Enclosure 3. Combined RAI Responses
Part 2 of 2

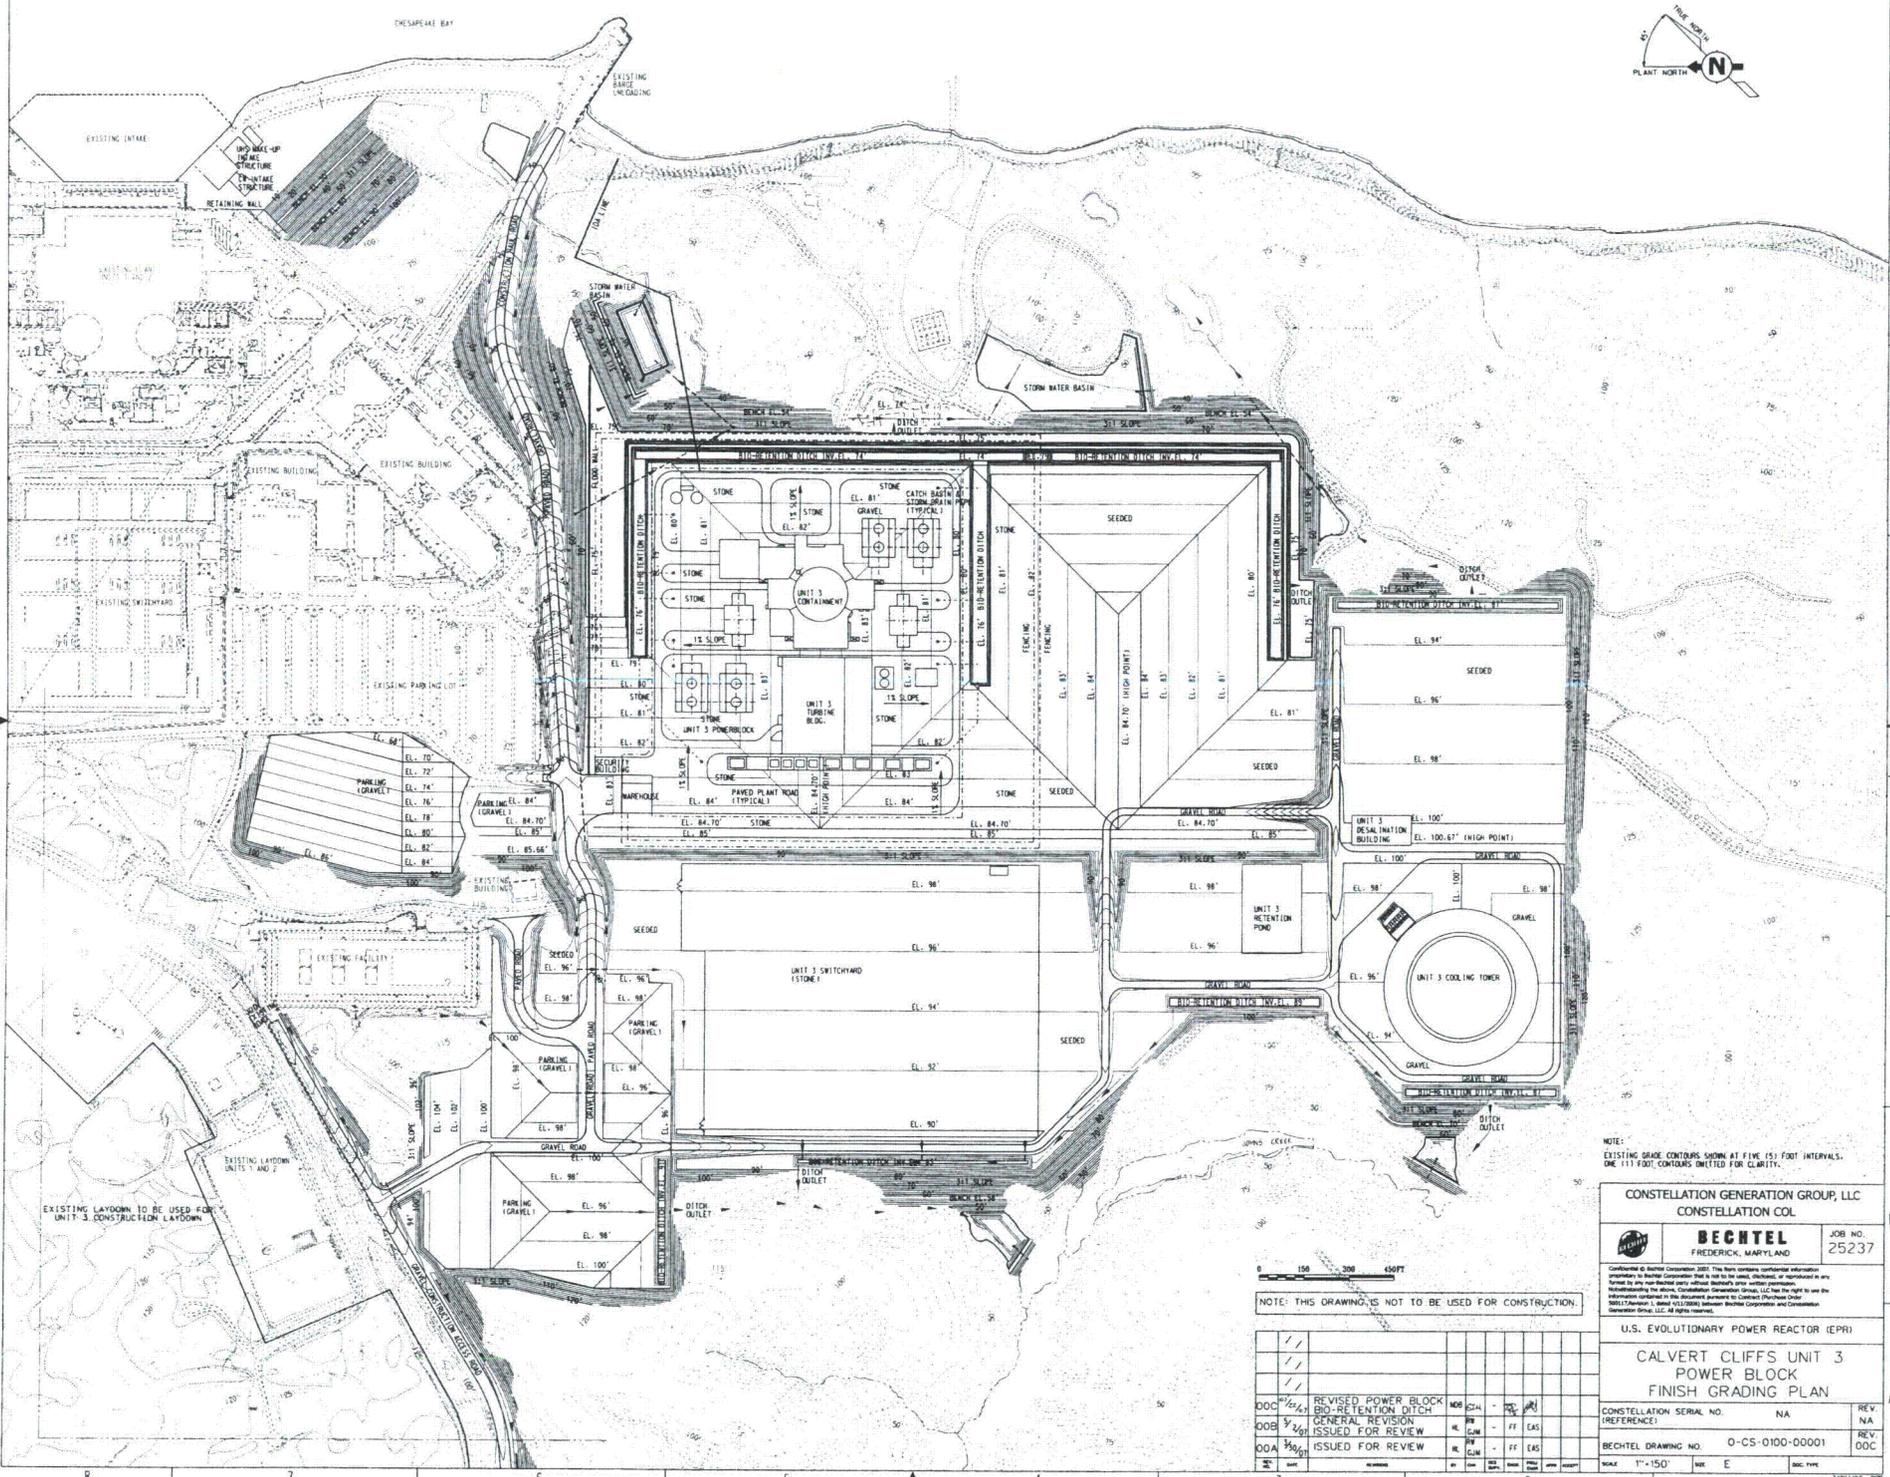
The attached drawing shows the areas that are to be reseeded at the end of construction. Areas not seeded will be left as gravel areas. Additionally, plans may be made to restore/reclaim those areas that are not reseeded or left as gravel.

No changes to the ER are required.

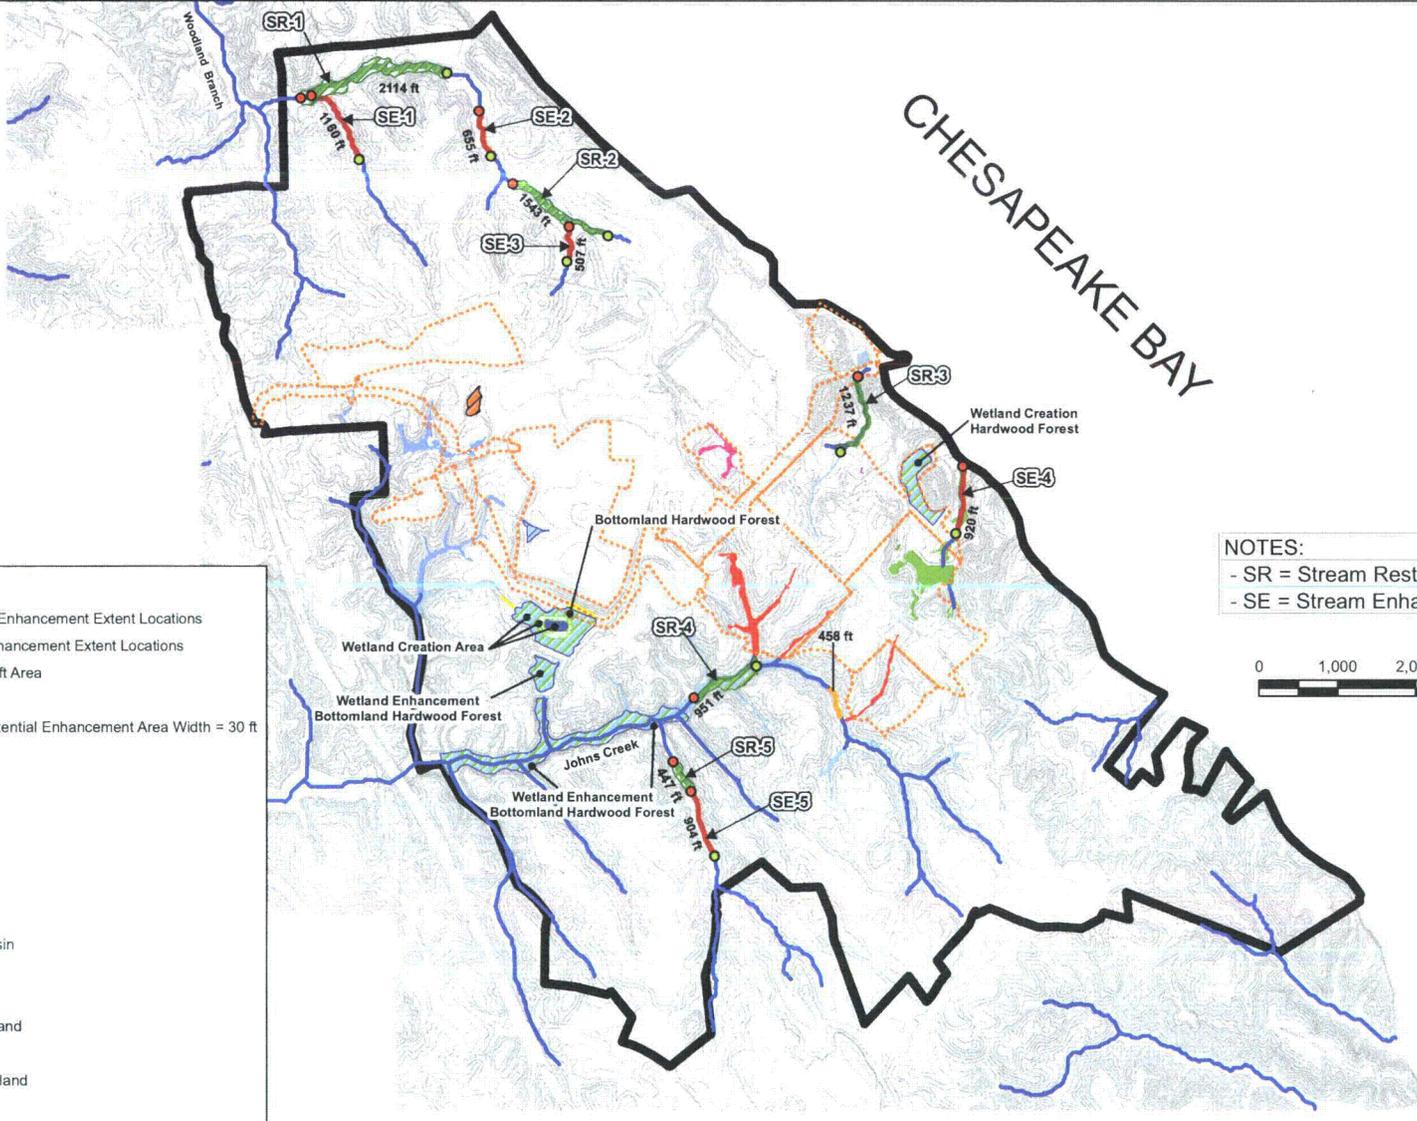
A complete walkthrough and inventory of plausible stream resources on the CNPP Unit 3 site was conducted on February 21 and 22, 2008. Following this walkthrough, field notes and photographic logs were compiled and the opportunity for physical, biological and, or riparian "lift" and corresponding compensatory mitigation activity was realized at various locations throughout CCNPP. CCNPP stream restoration and enhancement (SR-X and SE-X) sites selected as candidates for compensatory mitigation are shown in Table 1 and Figure 1 (attached).

Table 1 will be added to ER Section 4.6, and Figure 1 will be added to ER Section 7.2 in a future ER revision.

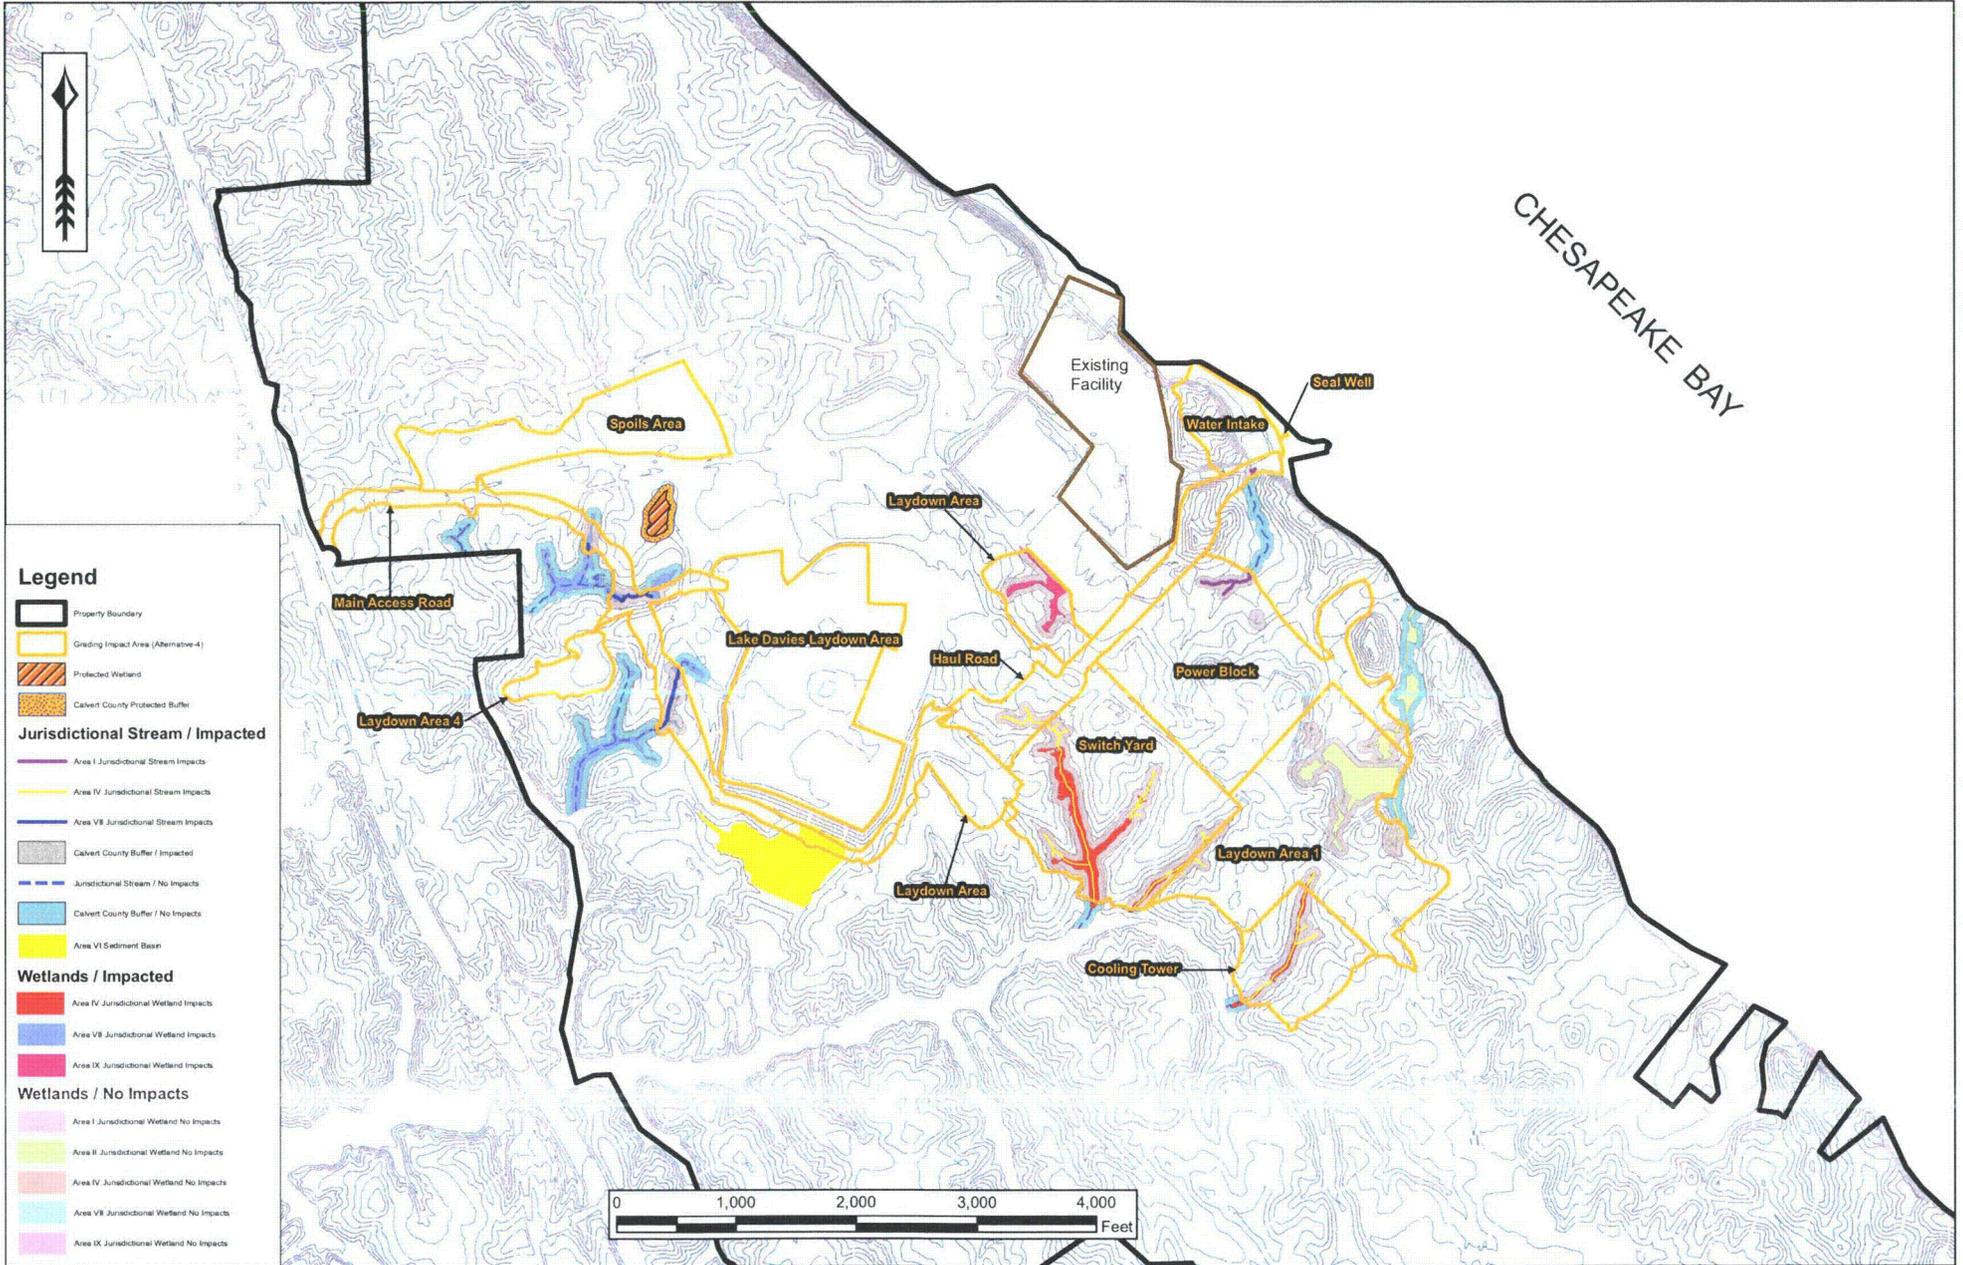
Provide one clear, readable map that shows the complete footprint of the new plant in relation to all of the freshwater bodies that would be impacted.
